Town of Hampden

Planning Board

F.A. PEABODY
NEW OFFICE BUILDING
36 & 38 MAIN ROAD NORTH
HAMPDEN MAINE

To: Shelly Lizotte, P.E.
CC: Myles Block, CEO, Sean Currier, DPW Director, and Chief Rogers, Public Safety Director
From: Karen M. Cullen, AICP, Town Planner *KMC*
Date: May 31, 2018
RE: FA Peabody Site Plan Submission

PROPOSED SITE PLAN & EROSION CONTROL PLAN/DETAILS

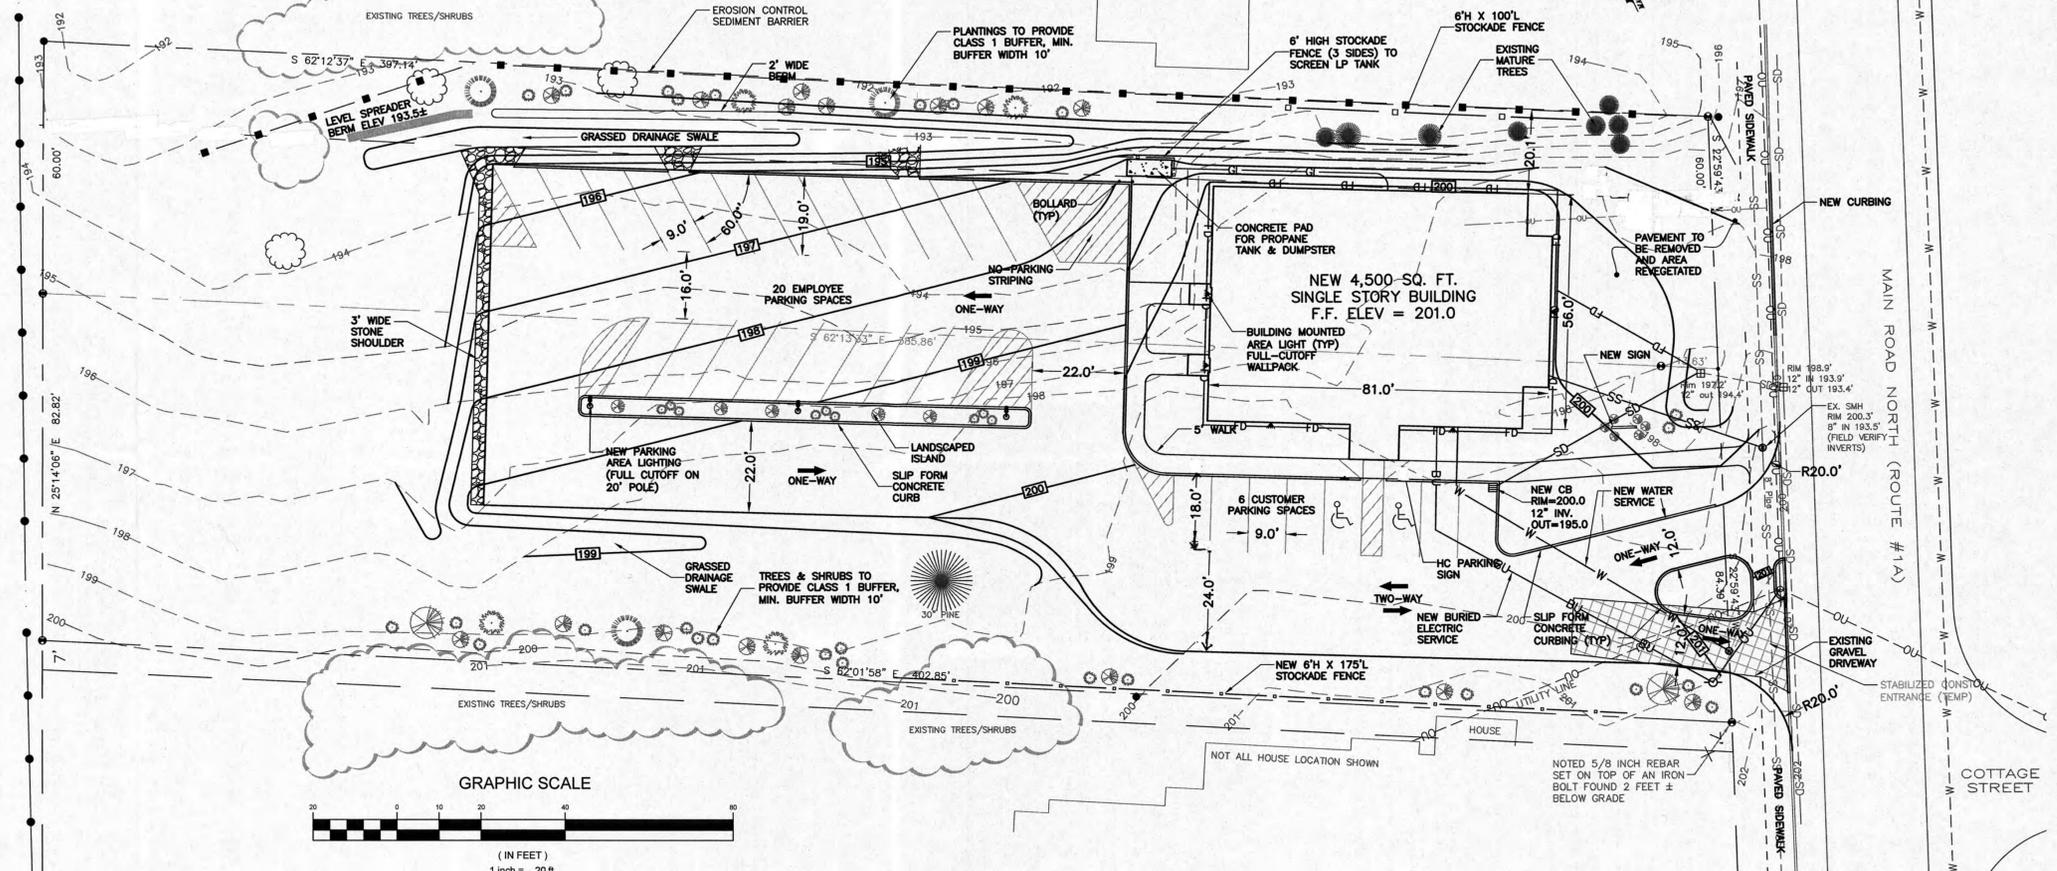
- #10 – sanitary sewer is not shown (or I can't find it)
- #12 – intensity, type, size, and direction of all outdoor lighting is not provided
- #16 – size of the freestanding sign is not provided. In addition, the Planning Board will want to know if there are any wall signs and what size it (they) are.

§4.7.4.2, buffer – as drawn on the plan, the plantings don't meet the standard of a densely planted buffer. Question: the note on the plan regarding the stockade fence is clear, but the location of that fence is not – does it go along the edge of the parking lot?

#3 – ingress/egress: we need to see where the Cottage Street intersection is in relation to this site. I would also like to know what DOT's comments are to ensure the local and state approvals are consistent. Otherwise you may have to return to the Board for a revision of the site plan.

#9 – drainage: I'm concerned about runoff flowing (sheet or otherwise) onto the abutting property to the north. I don't believe a sediment control berm is a permanent solution to direct runoff. Also, the foundation drain outlet is too close to the property line, can it either be directed further west or into a dry well?

#12 – screening for dumpster, propane tank, etc.: I don't see a dumpster location on the plan. The propane tank doesn't appear to have sufficient buffering. The plants at the base of that slope appear to be small, but there is no information on the type or size of the landscaping (plants) so I cannot determine if they would screen the tank. In addition, I don't know where the stockade fence is planned to go, so cannot tell if that would screen the tank.

4.1.6 #10 The proposed Sanitary Sewer connection is now shown on the plan. We have been in contact with Sean Currier of the Town of Hampden Public Works and are coordinating the depth of the new service with him. The size is expected to be a 4" sewer service for the new office.

#12 Proposed building lights are shown on the site plan. These lights will be a downcast LED wallpack, similar to the attached manufacturer cut sheet. Wallpack lights will be a maximum of 81W LED light, mounted at approximately 9' above the building floor level. Lighting on new poles will be 102-watt LED full cutoff, Area type 3 distribution. Area lighting will be on a timer and will be shut off approximately one hour after dawn.

#16 A freestanding sign will be located as shown on the enclosed site plan, to comply with Section 4.7.2 of the Zoning Ordinance. Additionally, a wall sign will be included as shown on the enclosed elevation. The sign will include 12" letters and will be 12 feet long, complying with the 12 square foot limit. FA Peabody is contracting with Lee Merchant & Daughter signs, Caribou ME, to create the freestanding sign for the new office. The new office sign will be a maximum of 8' high and will be no more than 24 square feet.

4.7.4.2 Buffers: A note has been added to the plan to indicate that trees and shrubs will be a minimum of 4' high at the time of planting and a mature height of 6'. Plants will be spaced to create a dense screen of at least 5' wide. A stockade fence will be along the Southerly property line to buffer the entrance and parking from the adjacent property owner. Any plantings along this fence will be ornamental and designed to enhance site aesthetics. The stockade fence on the north side of the building is to buffer the Northerly neighbor from the dumpster and propane tanks. The fence will be 3 sided and may include a gate to complete the enclosure.

#3 We have submitted and received an approval for a Maine Dot Entrance permit for the new office. A copy of the permit is attached. The letter from MeDot states the entrance shall be 25' from Cottage Street as shown on the plan submitted with the application, the same location as the entrance is shown on the Site plan submitted to the Town. The site plan shows Cottage street and the distance from the entrance to Cottage street is now indicated.

#9 Surface drainage of runoff from the parking and drive areas will be directed to the north edge of the paved parking. The site plan now shows a concrete slip form curb for a portion of the parking along this side, in addition to two curb-cuts and riprap drainage aprons from these curb-cuts. Drainage will be directed to the bottom of the slope at the riprap aprons, to a grassed drainage swale (excavated to be 12" deep) running along the northerly property line toward the back of the site, and toward the natural low area where it will terminate in a level spreader to distribute the runoff approximately 20' from the property boundary.

1 SOUTH ELEVATION
SCALE = 1/4" = 1'- 0"

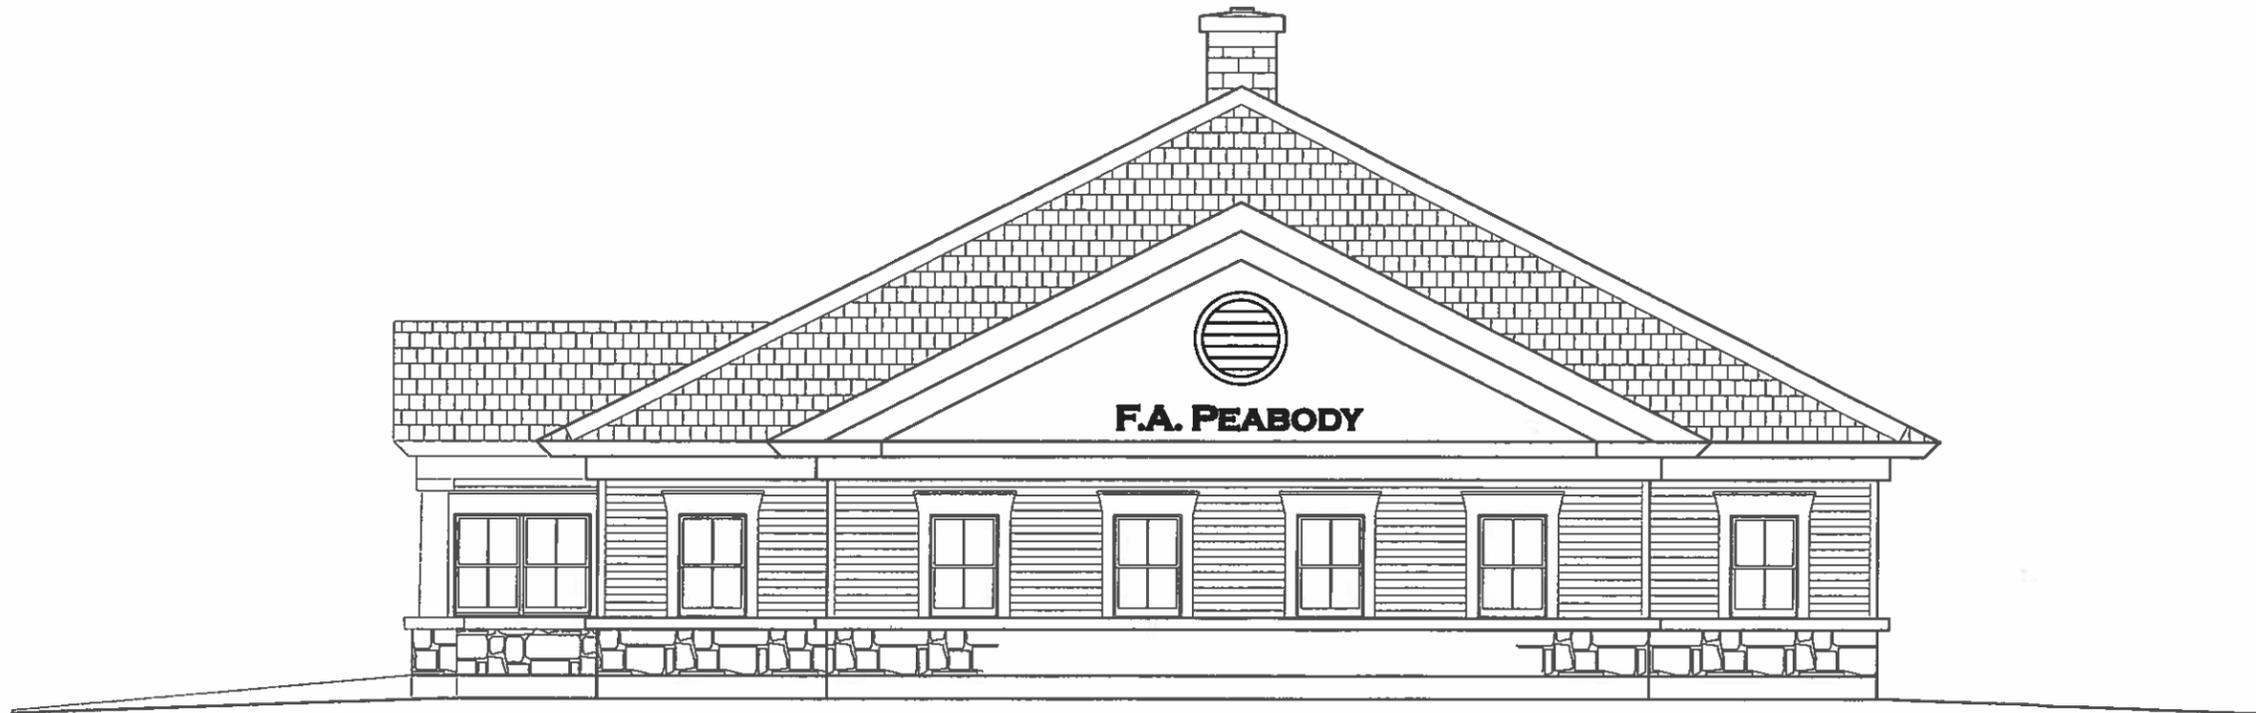
- #1 – compliance with applicable regulations:
 - §3.1.4.6.1b, architectural design – the type of siding doesn't appear to comply with this based on the submitted elevation drawing, although the PB may be fine with it.
 - §3.1.4.6.1c, amount of glass – no information is provided to determine compliance. I suspect it does comply, but can't tell without the window sizes.
 - §4.7.1.1, parking requirement – the plan exceeds the required minimum by 10 spaces (18 required, 28 provided, which is 1 space per 160 square feet, the requirement is 1 space per 250 square feet). Why so many spaces? Is there documentation
